**AGENDA
CITY OF ALLEN
PLANNING AND ZONING COMMISSION
REGULAR MEETING
TUESDAY, MAY 16, 2017 – 7:00 P.M.
CITY COUNCIL CHAMBERS
ALLEN CITY HALL
305 CENTURY PARKWAY
ALLEN, TEXAS 75013**

4. Public Hearing – Conduct a Public Hearing and consider a request to amend the development regulations for Planned Development No. 54 and adopt a Concept Plan and Building Elevations relating to the use and development of Lot 8R, Block D, Bray Central One Addition; generally located at the northwest corner of US Highway 75 and McDermott Drive (and commonly known as 802 W. McDermott) [RaceTrac McDermott]

AGENDA DATE:	May 16, 2017
SUBJECT:	Conduct a Public Hearing and consider a request to amend the development regulations for Planned Development No. 54 and adopt a Concept Plan and Building Elevations relating to the use and development of Lot 8R, Block D, Bray Central One Addition; generally located at the northwest corner of US Highway 75 and McDermott Drive (and commonly known as 802 W. McDermott) [RaceTrac McDermott]
STAFF RESOURCE:	Madhuri Mohan, AICP Senior Planner
PREVIOUS COMMISSION/ COUNCIL ACTION:	May, 1993 – Planned Development No. 54 Adopted July, 1998 – Planned Development No. 54, Tract

D CANOPY FRONT ELEVATION

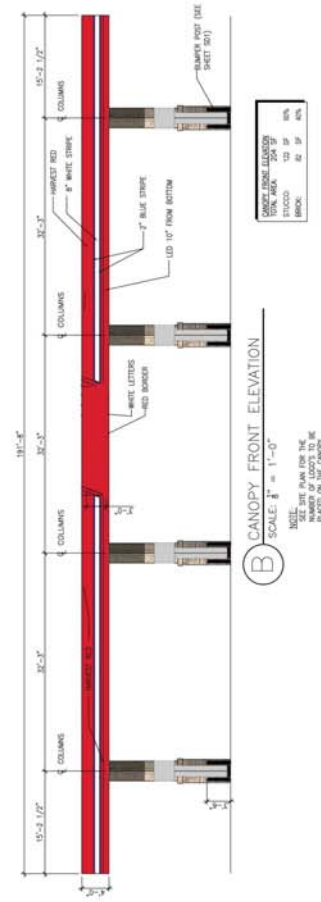
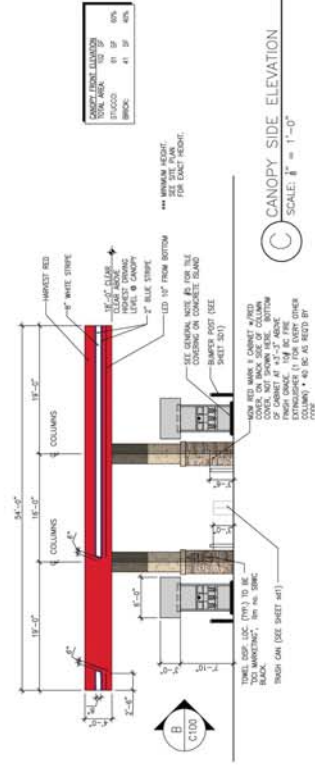
The fueling station canopy of this RaceTrac does not show a mansard roof as the applicant has refused to provide it. A mansard roof has been the City's policy; staff does not support the lack of a mansard roof at this prominent street intersection. This type of roof adds additional value to fueling stations and more effectively hides mechanical equipment of fueling stations and has become the new standard in the City. The previous two RaceTrac developments in the City have provided a mansard roof, as has the Allen Independent School District Service Center - voluntarily. Therefore, due to the lack of a masonry roof, staff recommends denial of the request.

- (1) The red fueling station band may not be more than six inches (6") wide.
 - (2) The fueling station canopy shall be designed and constructed with a mansard roof.

Therefore, considering the age of the canopy and its present condition it is my professional opinion that the existing canopy structure will not support a mansard addition.
